Service Bulletin No.: DAC1-73-04 Rev 4

Date Issued: 29 September 2008

Title: Engine Fuel System Conversion
IO-240-B17B to IO-240-B3B

Figure 2 – Plug Mixture Cable Hole in Aft Baffle

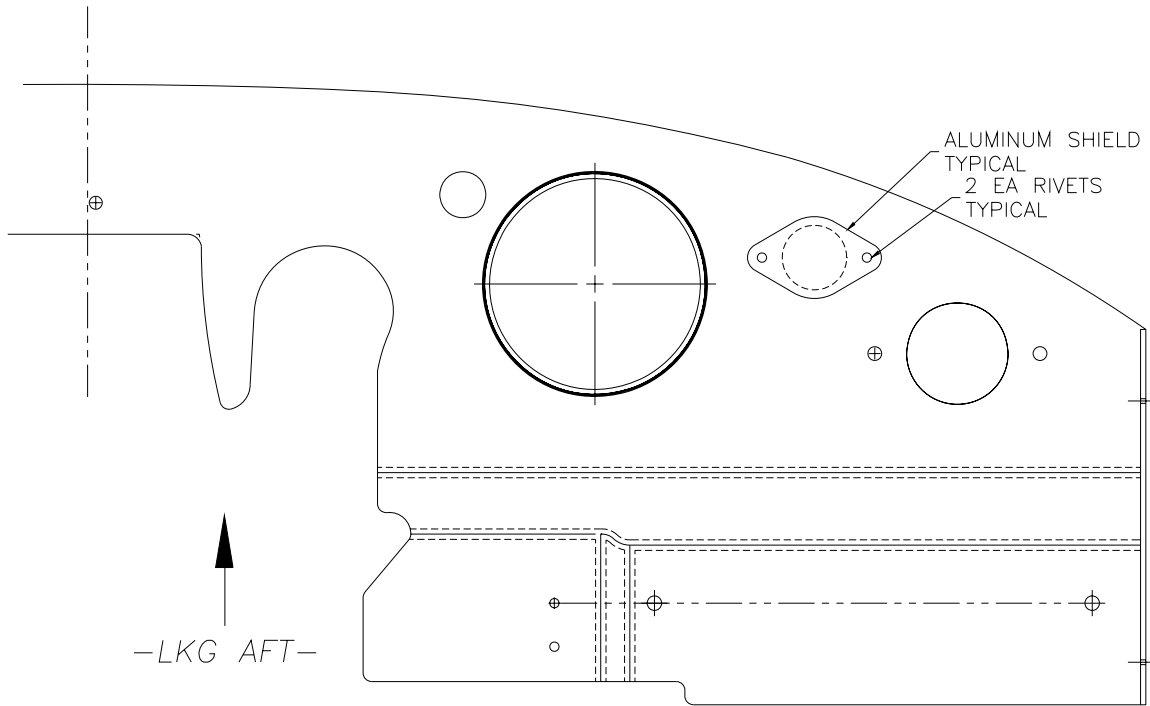
- 10.4.11** Fabricate aluminum blanking plate and plug transducer hole on the left side of the aft baffle as shown in Figure 2.

Figure 3 – Fuel Pressure Transducer Installation

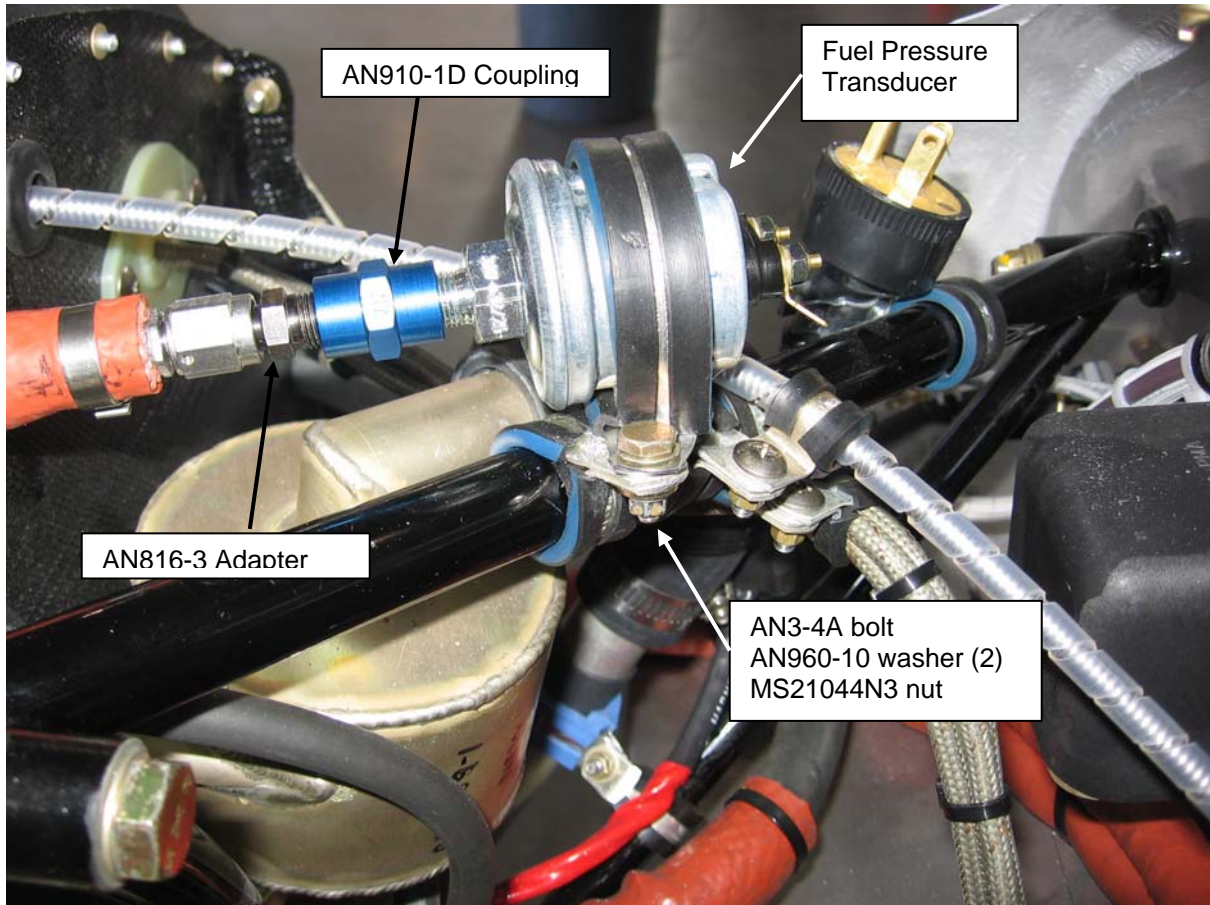
- 10.4.4** Install the fuel pressure transducer on the fuel hose AE3660001B0084 with AN816-3 Adapter and AN910-1D coupling then install pressure transducer on engine mount with P-clamp MS21919WCG24, AN3-4A bolt, AN960-10 washers and MS21044N3 nut. Refer to Figure 3.
